Technical Service Bulletin: tsb100778

New Flywheels and Flywheel Housings

This Technical Service Bulletin replaces 07T16-2. Two additional new flywheel housings have been added to Table 1, Part Numbers 4942185 and 4942186. This Technical Service Bulletin announces a standardization of flywheels which will eliminate the need for starter motor spacers. Several new flywheels and flywheel housings have been released.

Figure 2, Old Flywheel Housing - 106 mm [4.2 in] with Step-down to 92.05 m [3.6 in] Starter Bore

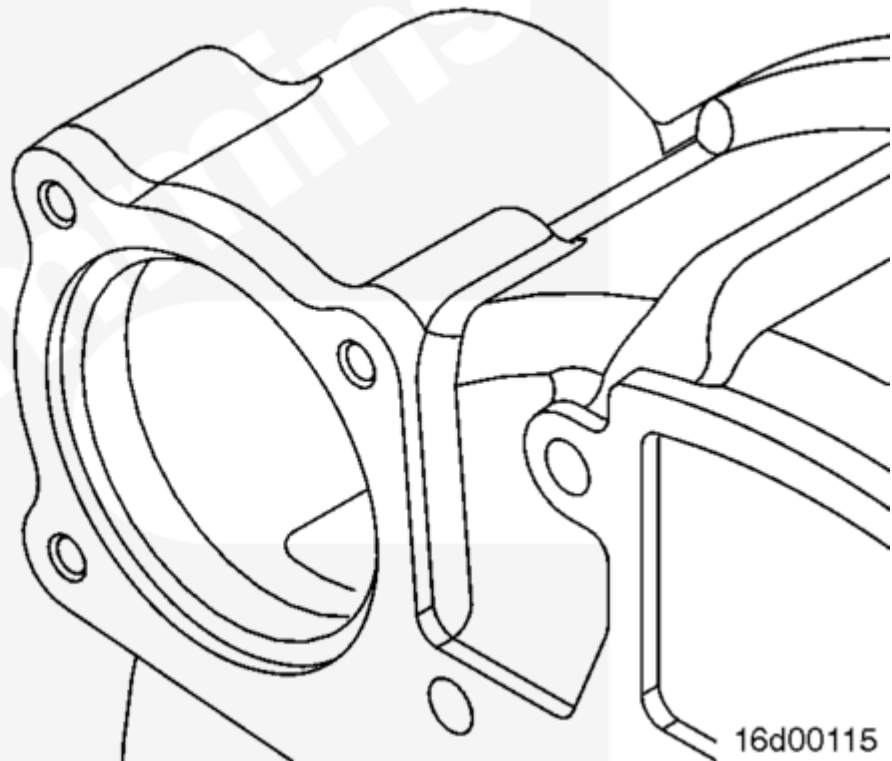
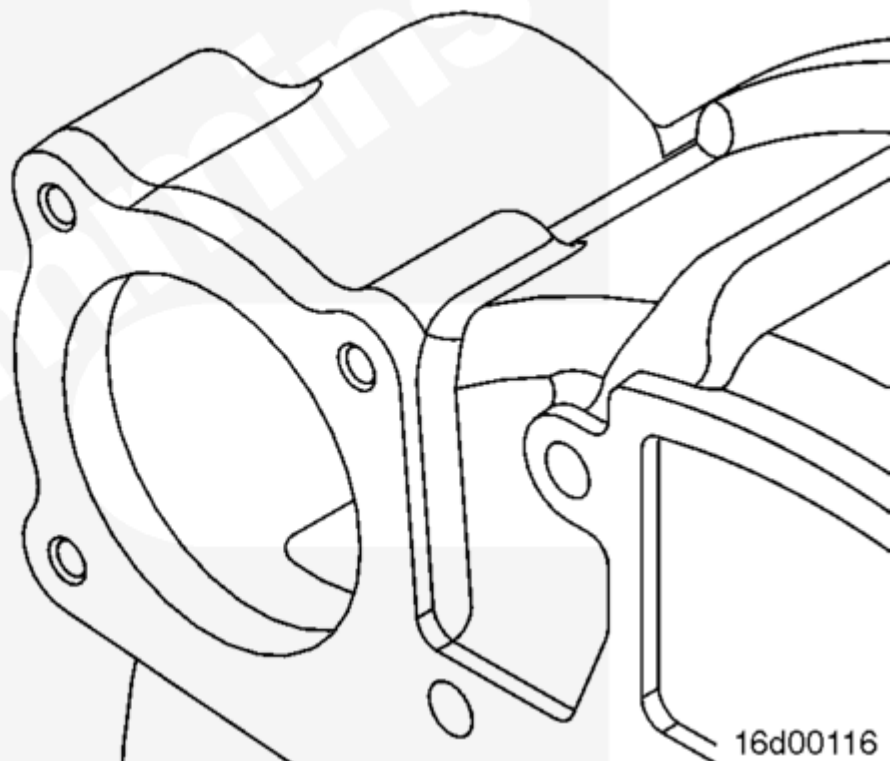
The new flywheel and flywheel housing hold a constant spacing between the starter mounting plate on the flywheel housing and the flywheel.

The new flywheel and flywheel housing part numbers will obsolete and supersede the present part numbers. See Table 1, Flywheel Housing Part Number Changes for direct supersession information. See Table 2, Flywheel Part Number Changes, for direct part number supersessions and for the compatibility information/conditions existing when using a new flywheel with an old flywheel housing.

Note : If a new flywheel is used with a new flywheel housing, no spacer is used.

Note : A new flywheel housing can not be used with an old flywheel.
